Access Compliance Report

Public Rights-of-Way

Intersection ID: 28002	Main Street: COLONIAL_COUNTRY_LN	Cross Street: OLD_TAYPORT_PL	Location: E
ADA ID: 3D3591E52AB3	Ramp Type: PerpDiag	Initial Pass/Fail: Fail	Overall Compliance: No
Severity Score: 8.75			
Codes/Mitigation Info/Possible Solution		Field Measurements/Component Compliance

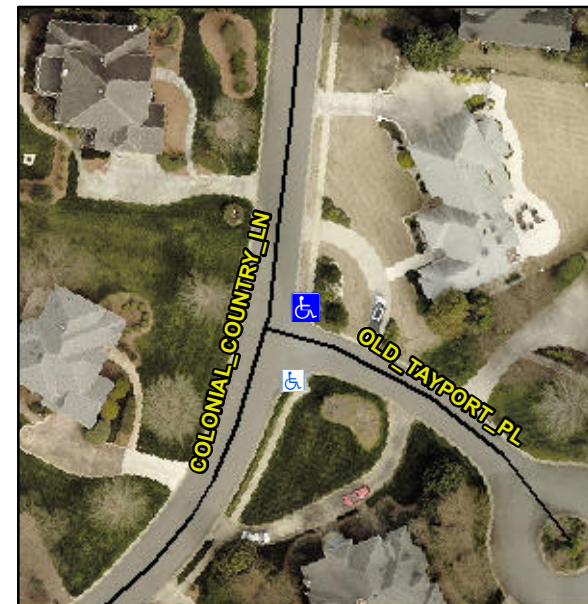
Not Found, R304.5.1

Compliance	Description	Data	Compliance	Description	Data
N/A	Ramp Length (in)	85.0	Yes	Ramp Slope (%)	7.0
No	Ramp Width (in)	40.5	Yes	Ramp XSlope (%)	0.5
N/A	Flare Type LT	N/A	N/A	Flare Type RT	N/A
N/A	Flare Slope LT (%)	N/A	N/A	Flare Slope RT (%)	N/A
N/A	Flare Traversable LT?	N/A	N/A	Flare Traversable RT?	N/A
N/A	Landing Length (in)	N/A	N/A	DWS Provided?	N/A
N/A	Landing Width (in)	N/A	N/A	DWS Contrast?	N/A
N/A	Landing Slope (%)	N/A	N/A	DWS Length (in)	N/A
N/A	Landing X Slope (%)	N/A	N/A	DWS Full Width?	N/A
N/A	Landing Curb? (Y/N)	N/A	N/A	DWS Offset (in)	N/A
N/A	Shared Landing?	N/A			
N/A	Gutter Ponding?	N/A	N/A	Gutter Slope (%)	N/A
N/A	Gutter Lip Ht (in)	N/A	N/A	Gutter X Slope (%)	N/A
N/A	Painted X Walk1?	No	N/A	Painted X Walk2?	No
	X Walk 1 Direction	To NW		X Walk 2 Direction	To SW
N/A	X Walk 1 Width (in)	N/A	N/A	X Walk 2 Width (in)	N/A
	X Walk 1 Slope (%)	3.4		X Walk 2 Slope (%)	3.0
	X Walk 1 X Slope (%)	1.6		X Walk 2 X Slope (%)	1.6

Remove & Replace Curb Ramp With Two New Directional Ramps or Equivalent.
